NOTICE OF MEETING
HILLSIDE REVIEW BOARD
CITY OF ST. GEORGE
WASHINGTON COUNTY, UTAH

HILLSIDE REVIEW BOARD AGENDA REPORT: **05/06/2015**

HILLSIDE DEVELOPMENT PERMIT: Case No. 2015-HS-001
Red Cliffs Park

HILLSIDE DEVELOPMENT PERMIT: Case No. 2015-HS-002
Simonsen

SLOPE MAP

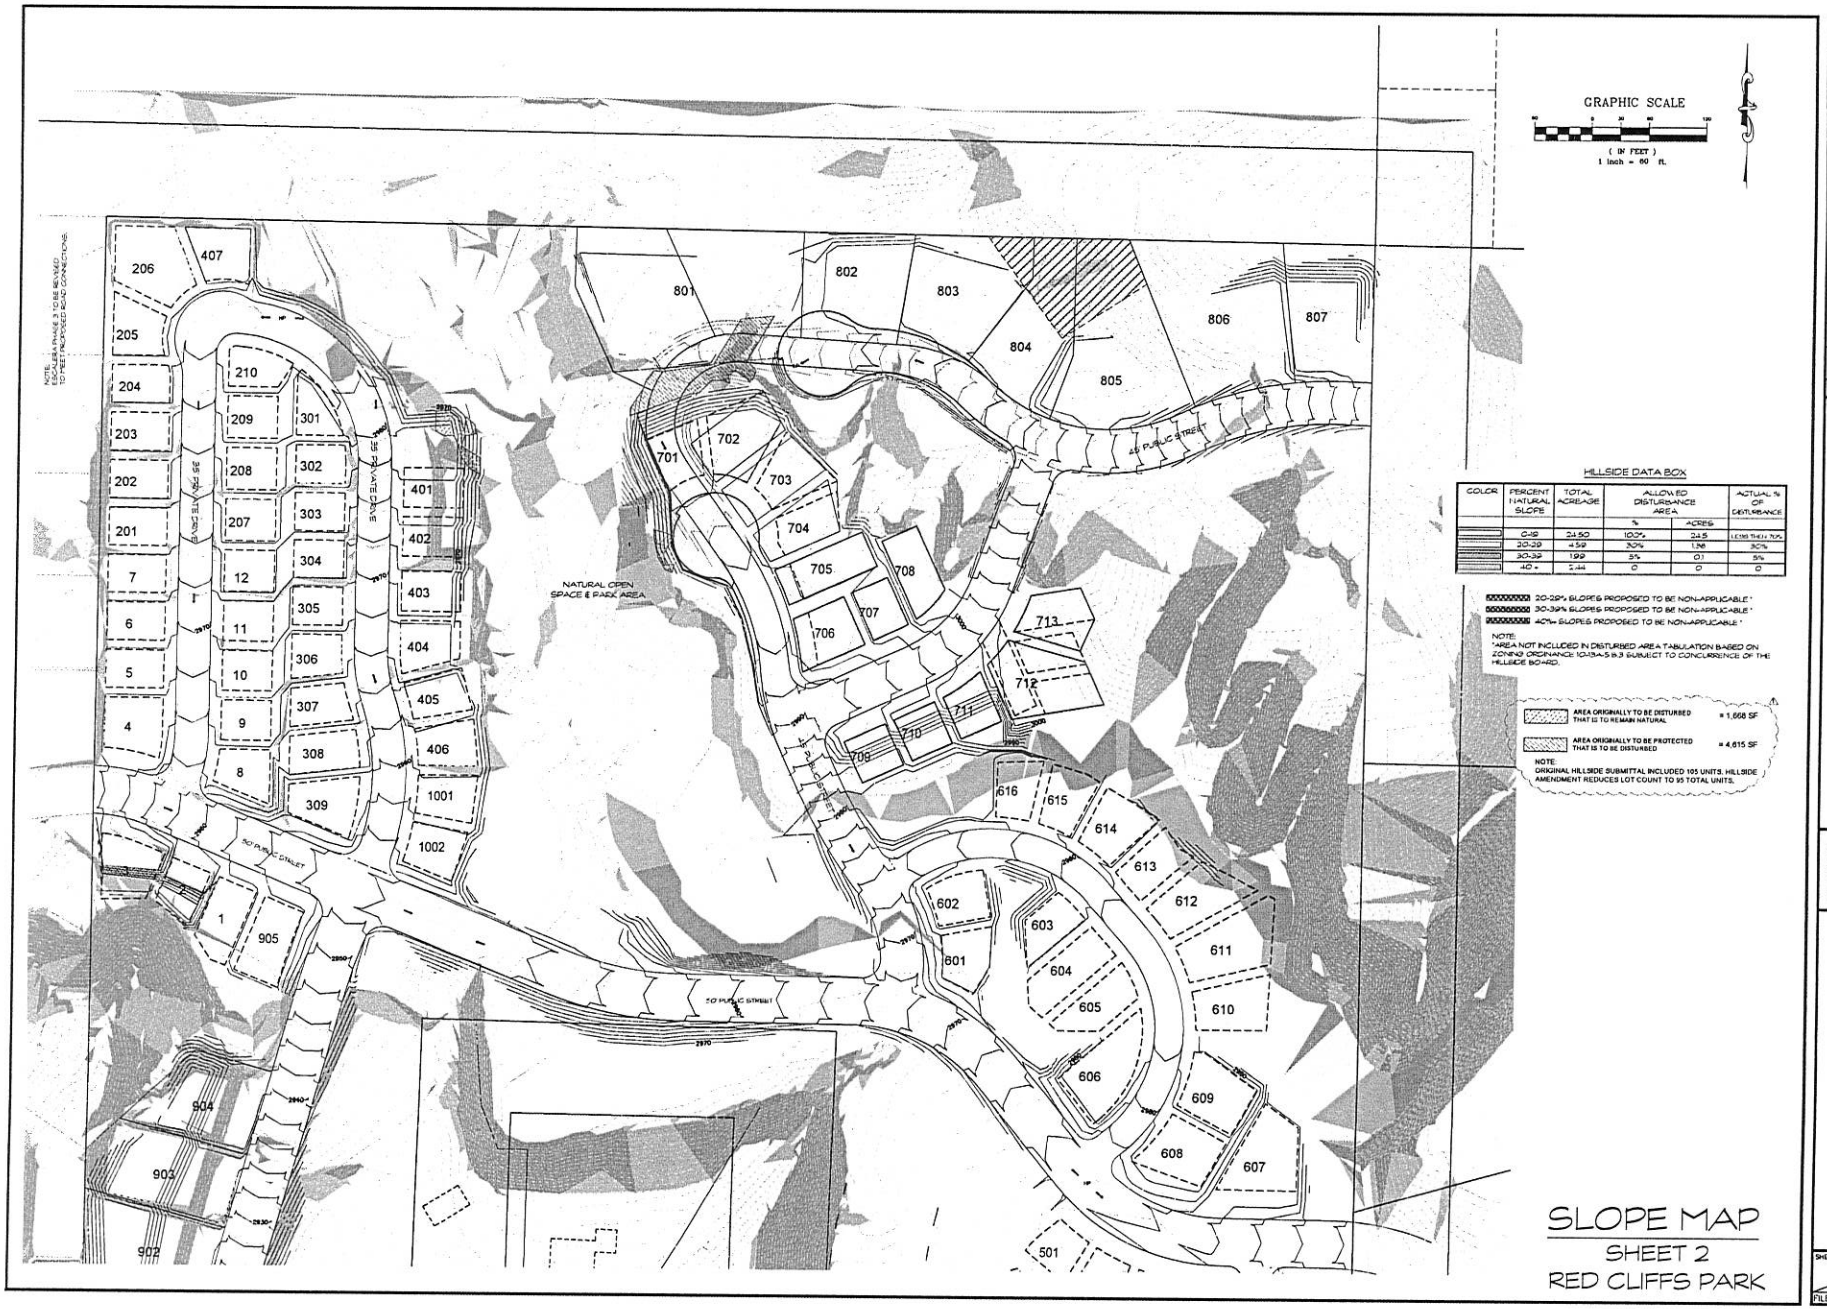
The applicant is proposing to connect two cul-de-sacs, in order to improve circulation and address sewer depth. According to the applicant, the project will generally remain within the required disturbance limitations per code. However, the applicant is requesting an increase in disturbance and requesting review, based on 10-13A-5:3 of the City Code. Areas may not be counted in determination of slope areas, under the following considerations:

Small washes or rock outcrops which have slopes distinctly different from surrounding property and not part of the contiguous topography may be excluded from slope determination if, in the opinion of the hillside review board, the exclusion of such small areas from slope determination will not be contrary to the overall purpose of this article.

The applicant believes the area meets the above criteria and is requesting the board review the wash. If the board determines it is an insignificant wash, the area will not be counted as part of the slope calculations for the project.

SITE PHOTOS

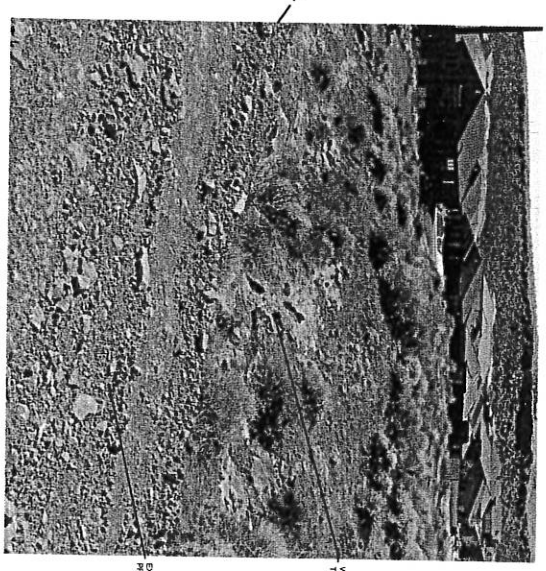
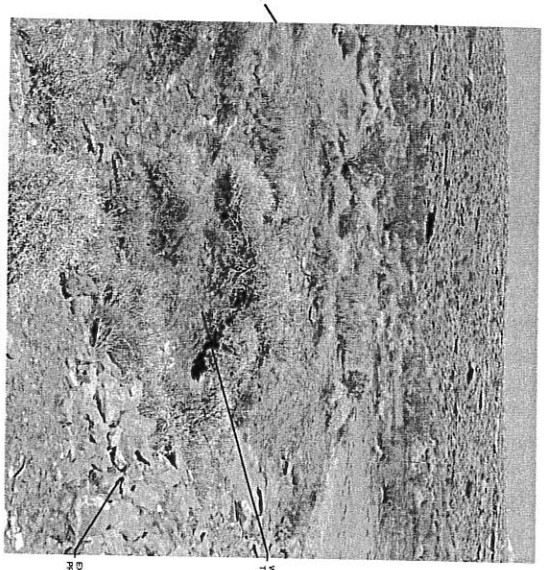
The area highlighted in purple on the attached exhibit represents area that is being requested to disturb. The area highlighted in red is area that had prior disturbance approval, but with this amendment, will remain undisturbed. Since this is the last phases of the project, most of the allowed disturb able areas have been graded. The difference of 2,947 square feet is the increase in disturbance.

WASH SLOPE PROPOSING TO BE DISTURBED

WASH SLOPE PROPOSING TO BE DISTURBED

Slopes Table				
Number	Minimum Slope	Maximum Slope	Color	Area
1	0.00%	19.99%		231239.96 sq.ft. - 5.31 Ac
2	20.00%	29.99%		42125.59 sq.ft. - 0.97 Ac
3	30.00%	39.99%		22329.54 sq.ft. - 0.51 Ac
4	40.00%	100.00%		9594.48 sq.ft. - 0.22 Ac

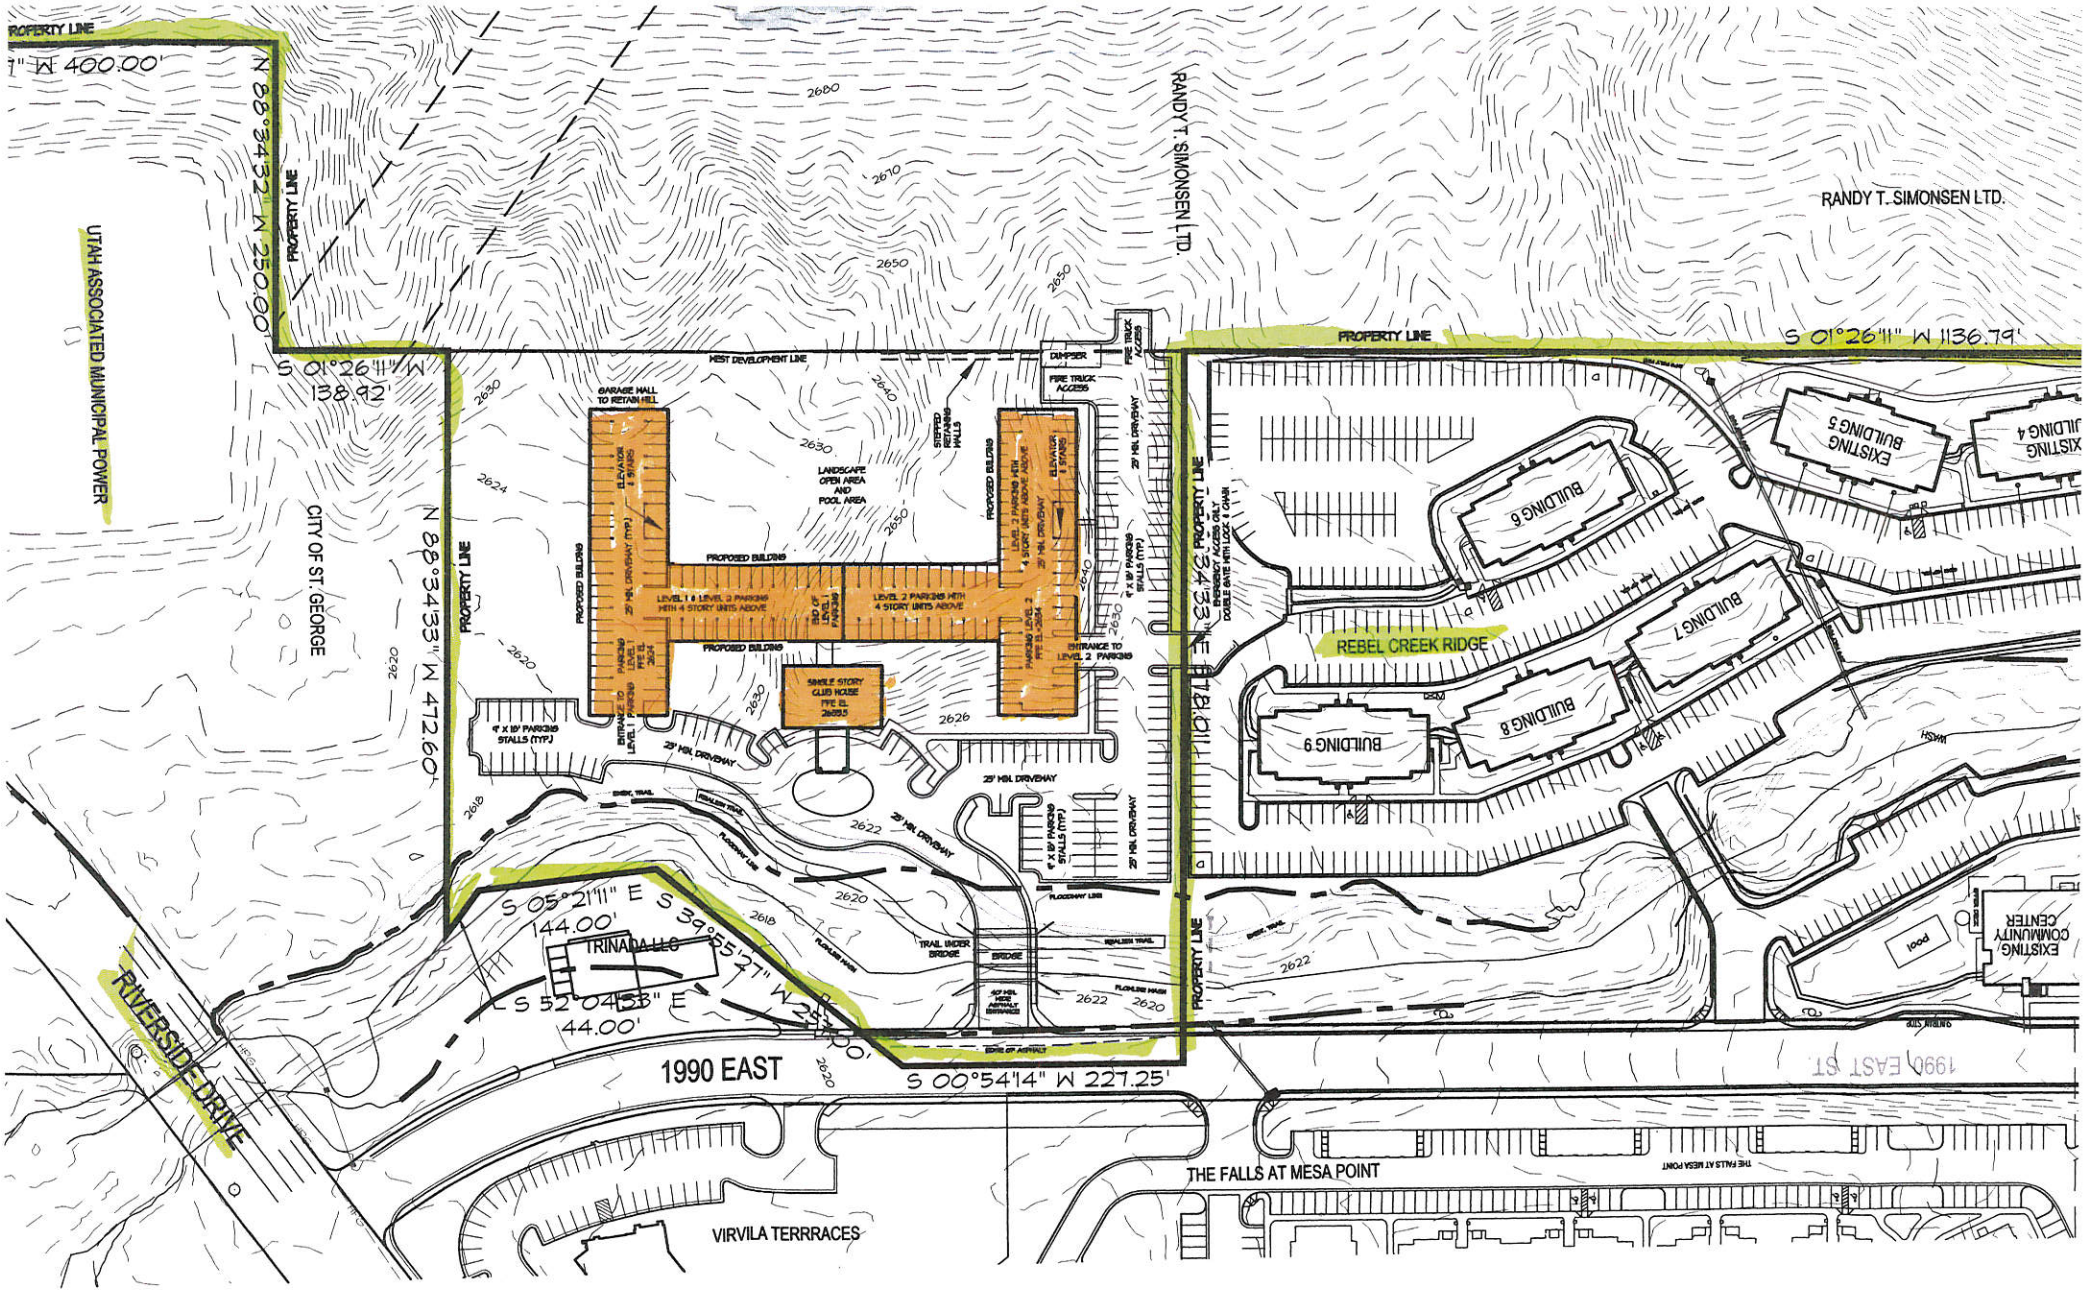
Comments: This area includes small isolated hills and mounds that are non-contiguous to any significant outcroppings and staff recommends they be allowed to be removed for multi-family site development.

A density transfer bonus has been requested for this site and staff will review all applicable codes and work with the applicant as required for determination if it may be granted.
